Docket Item # 5 & 6
BAR CASE # 2011-0273 &
2011-0274

BAR Meeting
October 19, 2011

ISSUE: Permit to Demolish/Encapsulate and Alterations

LOCATION: 511 South Lee Street

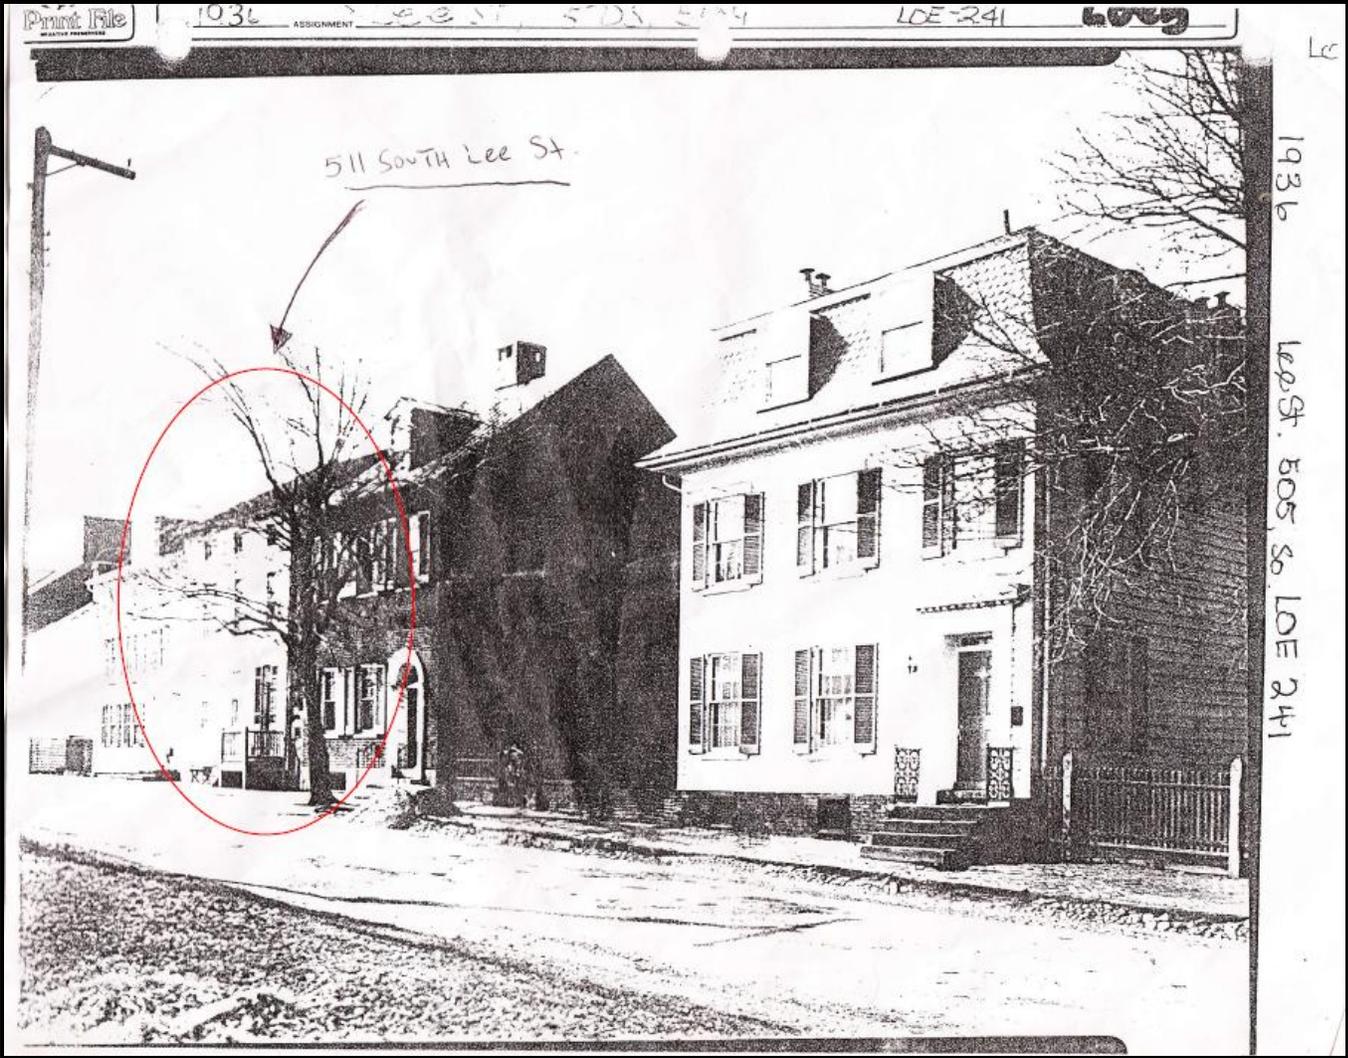
1. That the new wood stoop be constructed in the same location as the existing brick stoop; however, the stoop may be constructed approximately 8 to 9 inches wider, in its historic location, if the applicant obtains an Encroachment Ordinance from City;

2. That the proposed basement window under the new wooden stoop be deleted; and,
3. The statements in archaeology conditions below shall appear in the General Notes of all site plans and on all site plan sheets that involve demolition or ground disturbance (including Basement/Foundation Plans, Demolition, Erosion and Sediment Control, Grading, Landscaping, Utilities, and Sheeting and Shoring) so that on-site contractors are aware of the requirements:

Staff commends the applicant for undertaking the restoration of this historic townhouse and identifying historic photographs to help guide the restoration process. Staff has no objection to the removal of the brick stoop and stairs and the installation of a new wood stoop designed to match the one shown in the historic photographs, which meets the many guidelines for stoops, steps and railings outlined in the *Design Guidelines*. Wood stoops were much more prevalent historically than they are today, as evidenced by the photos provided by the applicant. Over time, many of these wood stoops have been replaced with more permanent masonry stoops, such as the one at 511 South Lee Street. While Staff would prefer to see the stoop widened to the full width shown in the photos (Figure 4 shows what is likely to be the footprint in the existing concrete sidewalk of one of the wooden posts, indicating the stoop originally projected approximately 8 to 9 inches further into the right-of-way), the City Code does not allow any additional encroachment beyond the current stoop. The applicants have indicated they may seek an Encroachment Ordinance from Planning Commission and City Council. Staff believes the sidewalk is wide enough in this location to support a larger stoop, but believe that a wood stoop in the same design as the historic stoop in the current location is also acceptable.

Staff also supports the applicant's request to slightly enlarge the two basement windows, given that there is clear evidence in the basement to suggest that at one time the windows were slightly larger. However, Staff does not support the installation of a third basement window on the front façade. Given the applicant's interest in an authentic restoration, and the lack of evidence on the interior basement wall supporting the existence of a window below the previous wood stoop, Staff does not find a compelling reason to support the addition of the third basement window. The proposed new single-glazed, true-divided-light wood windows comply with the Board's recently approved Window Policy.
